Response to Comments
on
Draft Permit Modification and Statement of Basis
for EPA's Proposed Remedial Action for the Housatonic River "Rest of River"
GE-Pittsfield/Housatonic River Site

U.S. Environmental Protection Agency
Region 1 (EPA New England)

October 2016

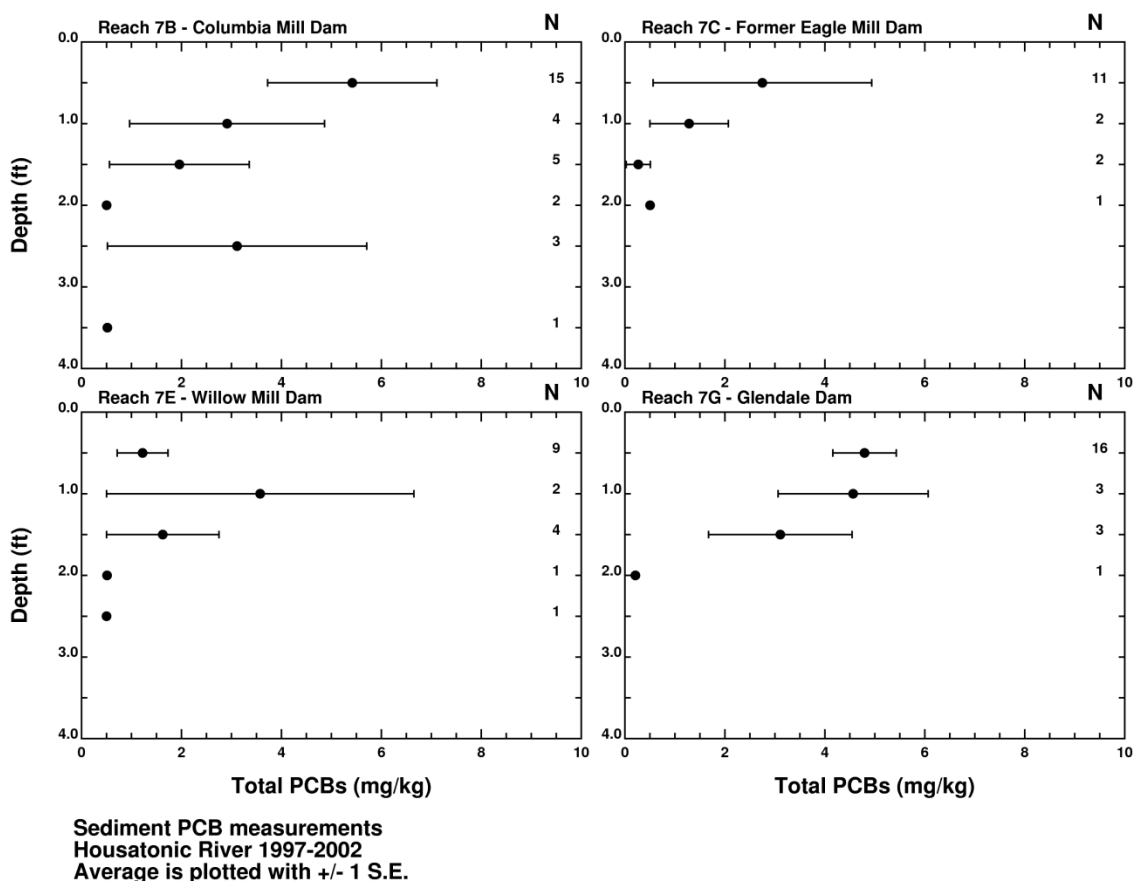
Comment 631: GE asserts the following: There is already considerable evidence of natural recovery in the Reach 7 impoundments, as indicated by a decline in PCB concentrations in fish, sediment, and water in the area; and that recovery will continue, given the recent and ongoing remediation efforts upstream of the Confluence and the anticipated remediation of the sediments in Reaches 5 and 6 (the only significant source to Reach 7), whether under the proposed remedy or a less intrusive but equally effective remedy, as illustrated by the model results. In addition, the Reach 7 impoundments are conducive to natural recovery, since expected human exposure is low and/or can be controlled by institutional controls, the impoundments are relatively quiescent and net depositional environments with a reasonably stable sediment bed and a low potential for scour, and sediment PCB concentrations are low compared to upstream areas and do not indicate the presence of “hot spots” (see [GE Attachment H]).

EPA Response 631: GE claimed in the comment that declining PCB concentrations in the sediment of Reach 7 Impoundments indicate that natural recovery is occurring there; however, no evidence is included in the comment to support the assertion and EPA does not believe that the claim of natural recovery can be supported with existing data. Analyses conducted by GE using data from Impoundments upstream and downstream of Reach 7 [i.e., Woods Pond and Rising Pond (RCRA Facility Investigation Report (RFI), GE, 2003)] do not support this assertion. In Section 4.6 of the RFI, GE concludes that the best fit approach results in a slope indicating a downward trend in PCB concentration in sediments. Further, GE concludes that:

Although slight downward slopes are computed in the regression analysis plotted in Figure 4-25, the relatively high p-values (all greater than a 95% significance level of 0.05) indicated that the downward slopes are not statistically significant. The results of this trend analysis should be interpreted with caution due to the limited data and high variability within the range of samples years. Indeed the

low r^2 values (all less than or equal to 0.1) shown on Figure 4-25 illustrate the importance of caution in interpreting these results, as the simple model of exponential decline over time explains less than 10% of the variability in surface PCB concentrations in these impoundments.

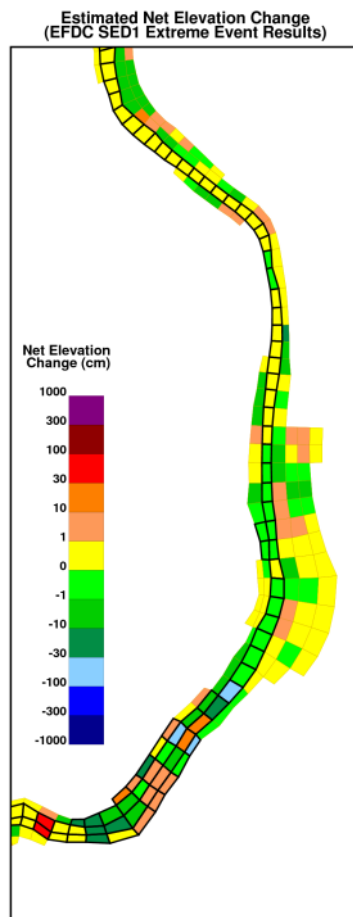
Also, EPA disagrees that the Impoundments have a low potential for scour. For example, the figure below shows model-computed shear stress and minimal stable particle sizes for Reach 7B during the 26th year of the model simulation when a high-flow storm event was included in the simulation. The erosion of the sediment bed from the storm in the Reach 7B Impoundment simulated by the model is shown below. The figure shows the grid cells that represent the Impoundment in the model. The color of the cells indicates the amount of erosion or deposition predicted by the model. Cells that are shades of green to blue shown the amount of erosion in centimeters, while those in yellow to purple show deposition. It is clear from this demonstration of changes in bed elevation that GE's claim that the Reach 7 Impoundments have a low potential for scour is not supported.
